**ALERT SERVICE BULLETIN**  
**Bell Helicopter** **TEXTRON**

NO. UH-1H-07-03

**MODEL AFFECTED:** UH-1H

**SUBJECT:** CYCLIC FLIGHT CONTROL BEARING, P/N MS27643 ONE TIME INSPECTION AND REPLACEMENT OF.

FIGURE 1

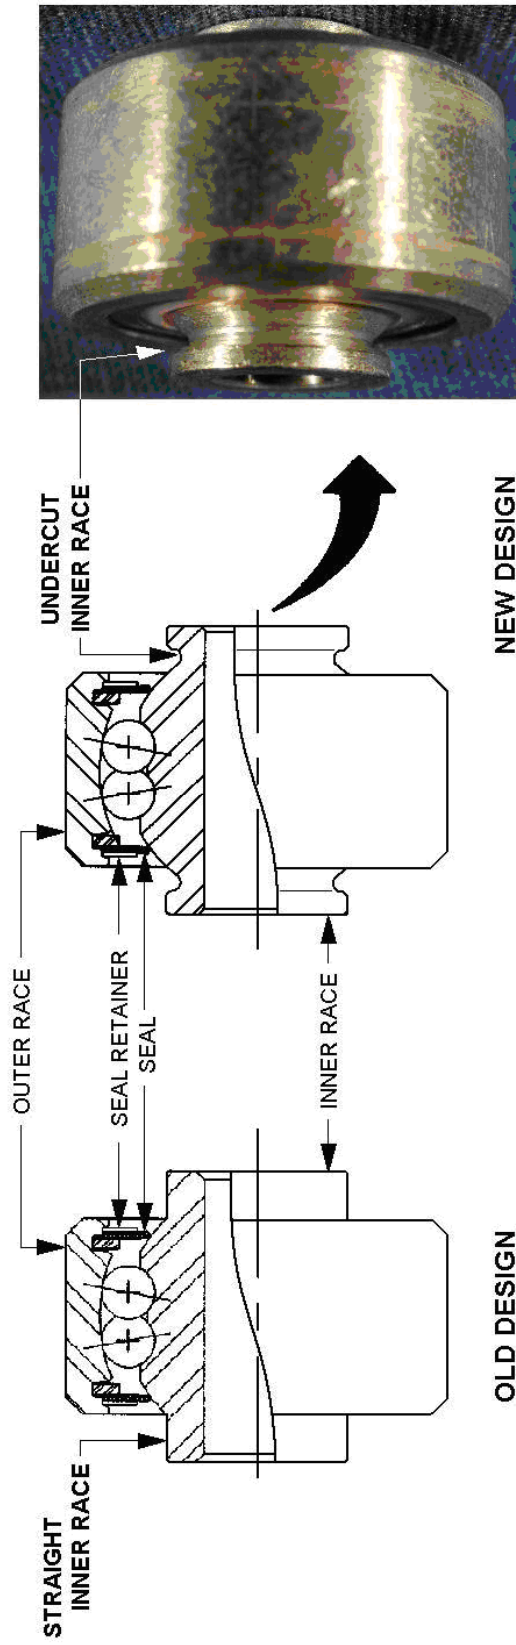
2. Bearings manufactured by Schatz Bearing Corporation will have the word **SCHATZ** imprinted on the bearing seal retainer on at least one side of the bearing as shown in Figure 1.

FIGURE 2

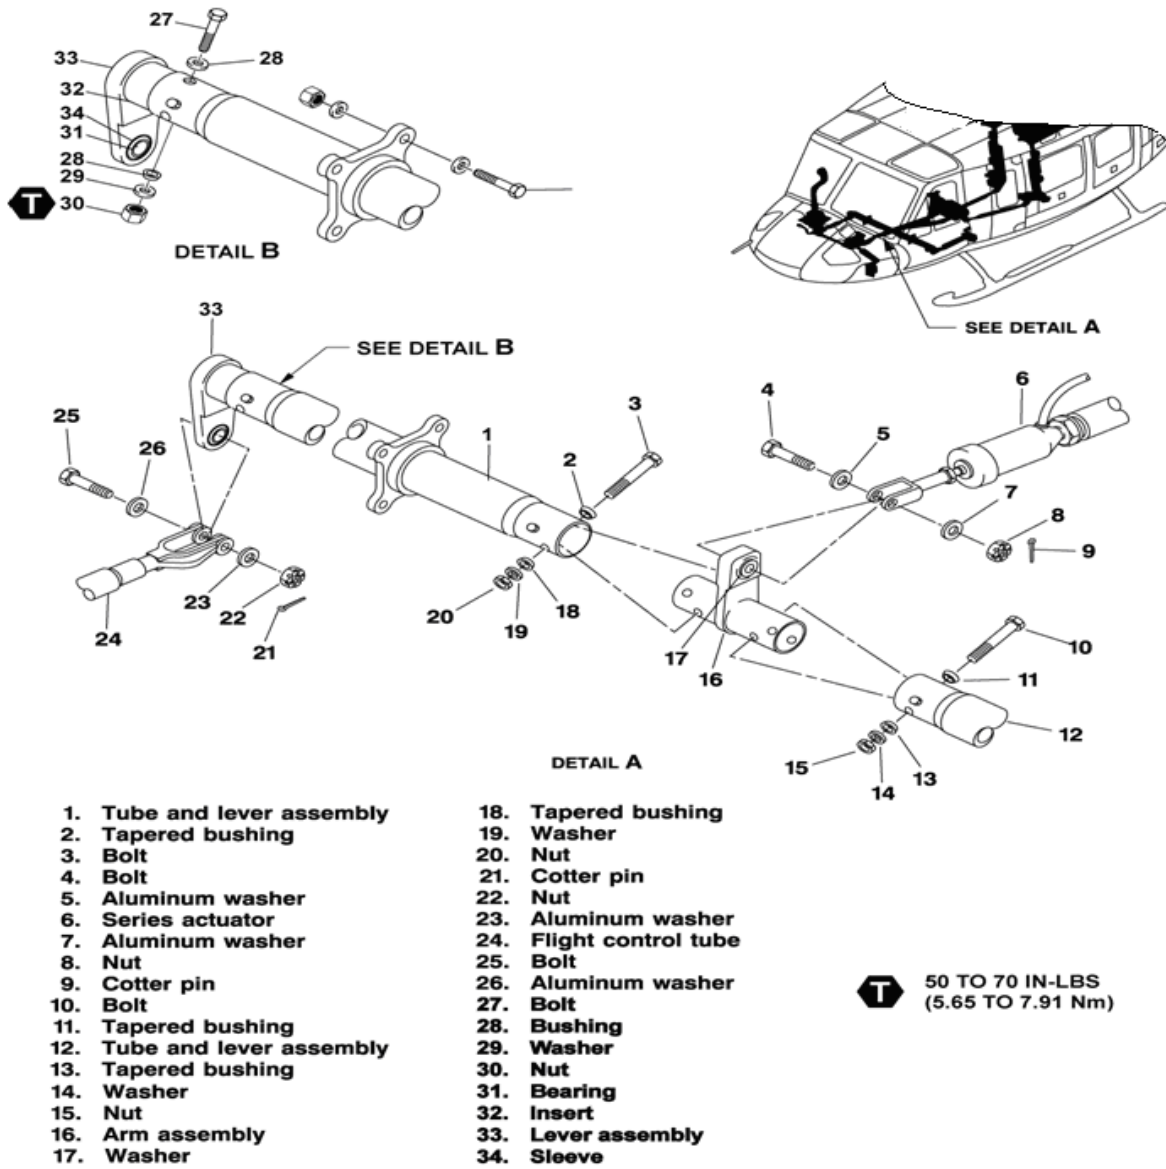
- a. Bearings previously manufactured by Schatz which do not meet the 10 degree minimum angular rotation requirement can be identified by the **straight shoulder inner race** design as illustrated in Figure 2 (**old design**).

- b. Redesigned bearings manufactured by Schatz which do meet the 10 degree minimum angular rotation requirement can be identified by the **under cut shoulder inner race** design as illustrated in Figure 2 (**new design**).

**OLD DESIGN**

DOES NOT ALLOW 10° MINIMUM  
ANGULAR ROTATION

**NEW DESIGN**

MEETS THE 10° MINIMUM  
ANGULAR ROTATION REQMT

- c. Inspect bearing in all 3 lug locations per Figure 2 for **old design** Schatz bearings as described in Component and Bearing Identification section.
  - 1) If **old design** Schatz bearings are found in any of the lugs they must be removed and replaced in accordance with the Compliance section and Accomplishment Instructions, Part III C, of this bulletin.

LEVER ASSEMBLY 204-001-332-001  
 FIGURE 3

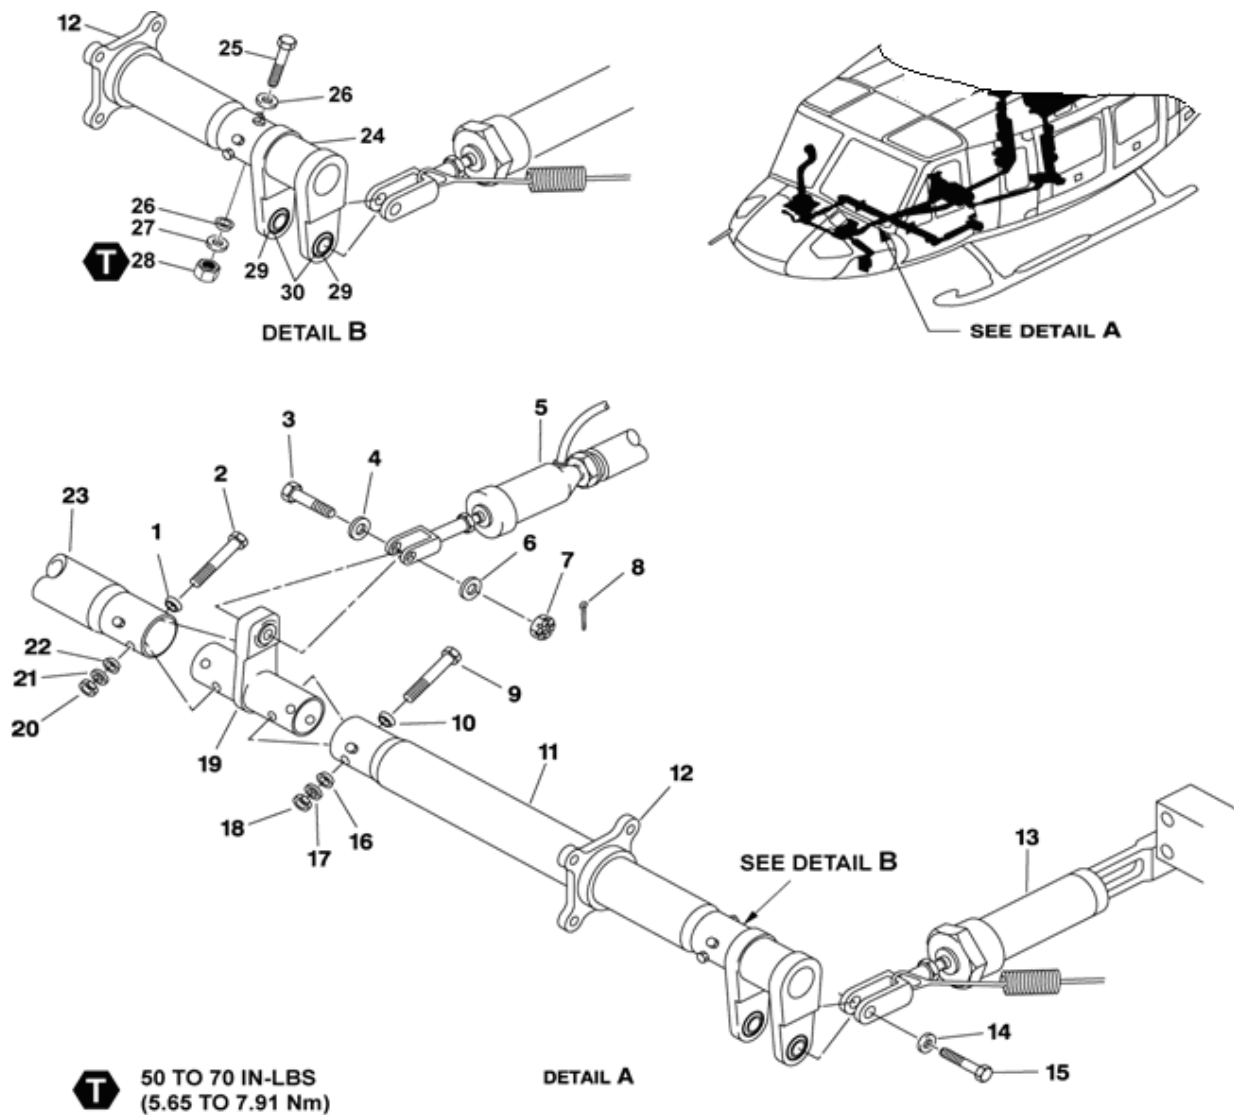
- a. Remove bolts (27, figure 3), nuts (30), washers (29) and tapered bushings (28) attaching components of tube and lever assembly (1).
  - b. Remove lever assembly (33) from tube (1).
  - c. Remove bolts (25, figure 4), nuts (28), washers (27) and tapered bushings (26) attaching components of tube (11) and lever assembly (24).
  - d. Remove lever assembly (24) from tube (11).
4. If wear or damage of component is suspected, refer to BELL-SPM for inspection criteria.
  5. Refer to Part III C for Bearing and Sleeve replacement.
  6. Assemble lever as follow:

- a. Insert lever assembly (33, figure 3) in tube (1) and align bolt holes.

- b. Apply primer (C-204) on bolts (27), taper bushings (28) and mounting surfaces of tube (1).
- c. Install bolts (27), tapered bushings (28), washers (29) and nuts (30). Torque bolts 50 to 70 inch-pounds (5.65 to 7.91 N-m). Washer must clear tube 0.030 to 0.060 inch (0.762 to 1.524 mm).
- d. Insert lever assembly (24, figure 4) in tube (11) and align bolt holes.

RING STAKE WORK-AID  
FIGURE 5

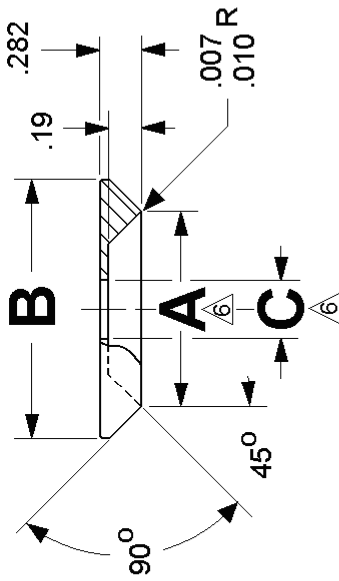
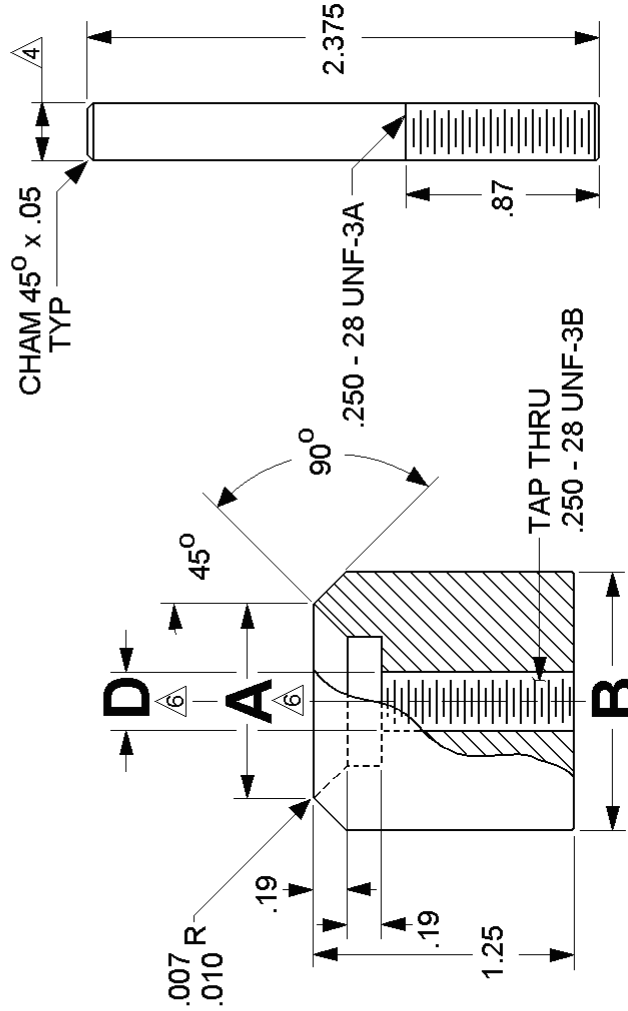
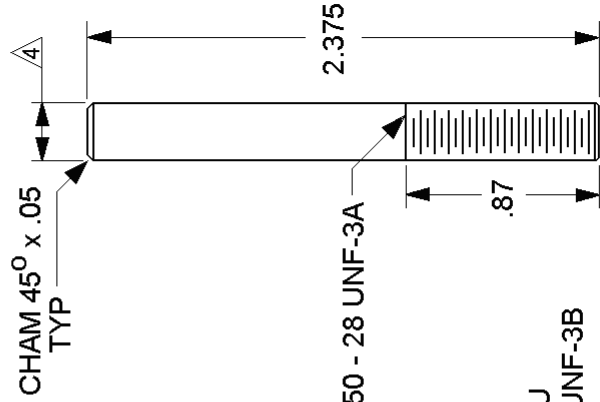
- a. Do not use zinc chromate or water borne (MIL-P-85582) primer, use MIL-P-23377 primer only when installing the sleeve and bearing.
- b. Heat may be applied to the component lug to aid sleeve installation. Do not exceed 200 degrees F. Allow primer to cure before installing the bearing.
- c. The new bearing may be chilled in a freezer or with dry ice to aid installation into the sleeve. Do not exceed 2 hours chill time and do not use liquid nitrogen or alcohol.
- d. Due to access limitations, P/N T101873-13 Ring Staking Tool can not be used to replace the bearing in the lateral lug of the P/N 204-001-357 Lever and is only marginally acceptable for the bearings in the P/N 204-001-356 Arm. A locally fabricated work aid (Figures 5 and 6) may be used to ring stake bearings in these areas.

1. DRAWING NOT TO SCALE.
2. ALL DIMENSIONS IN INCHES.
3. FABRICATE -1 AND -2 DETAILS FROM 4130 OR 4340 ALLOY STEEL, H.T. 140-160 KSI.
4. FABRICATE -3 DETAIL FROM .250 DIAMETER ALLOY STEEL BOLT
5. SURFACES W, X, Y, & Z TO BE PARELLEL WITHIN .005 T.I.R.
6. DIAMETERS A & C AND A & D TO BE CONCENTRIC WITHIN .005 T.I.R.
7. AS NECESSARY, ASSEMBLE -3 DETAIL TO -1 DETAIL WITH LOCTITE.

**LEVER ASSEMBLY 204-001-357  
FIGURE 6**

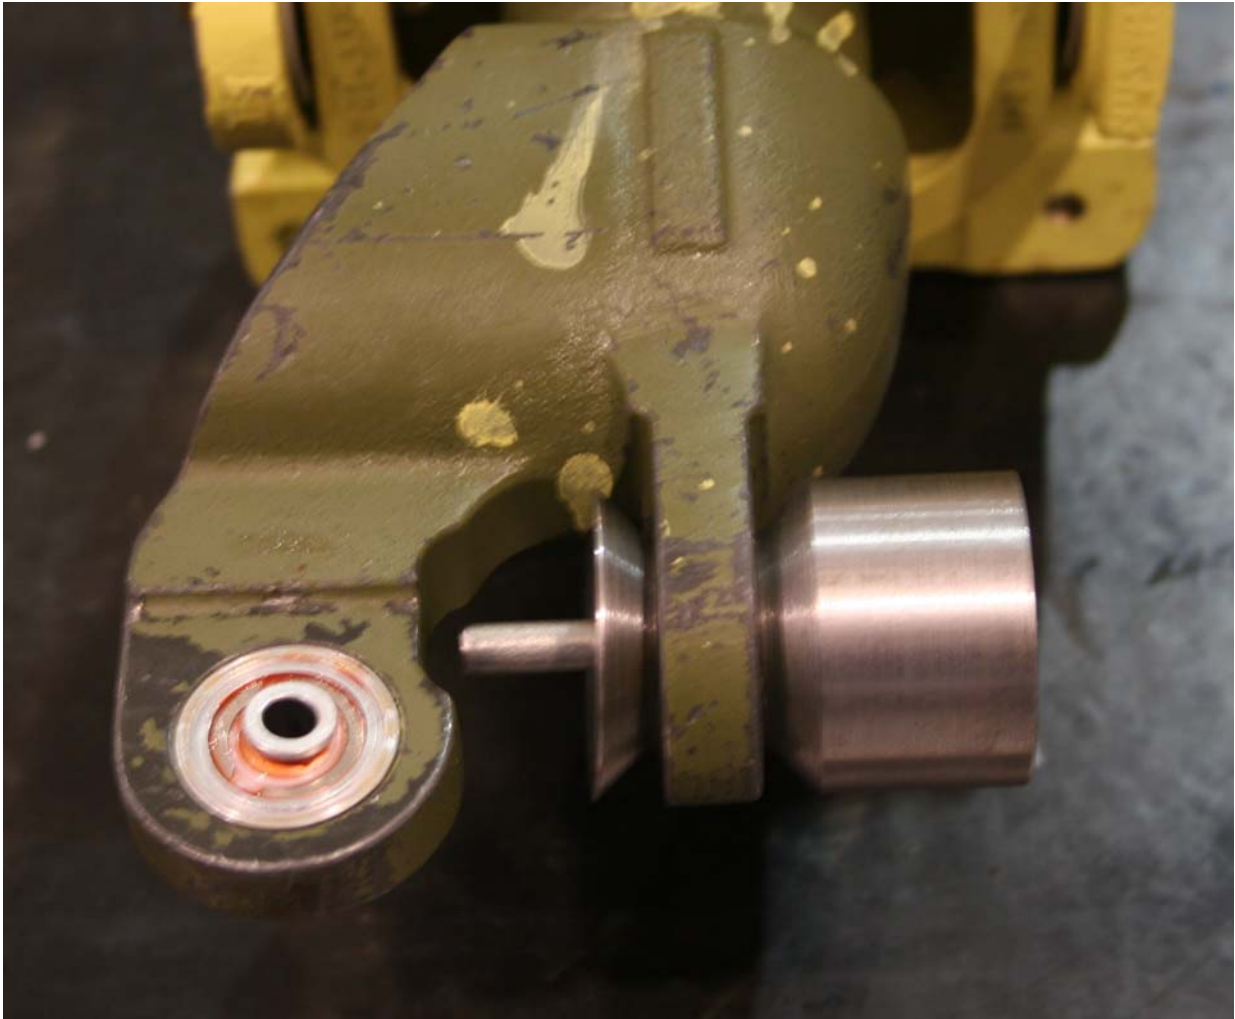
RING STAKE WORK-AID SHOWN INSTALLED ON  
LATERAL INPUT LUG OF THE P/N 204-001-357  
SUPPORT ASSEMBLY

ENSURE ALL LUGS ARE ADEQUATELY SUPPORTED  
DURING ALL PRESSING, REAMING, AND STAKING  
OPERATIONS.
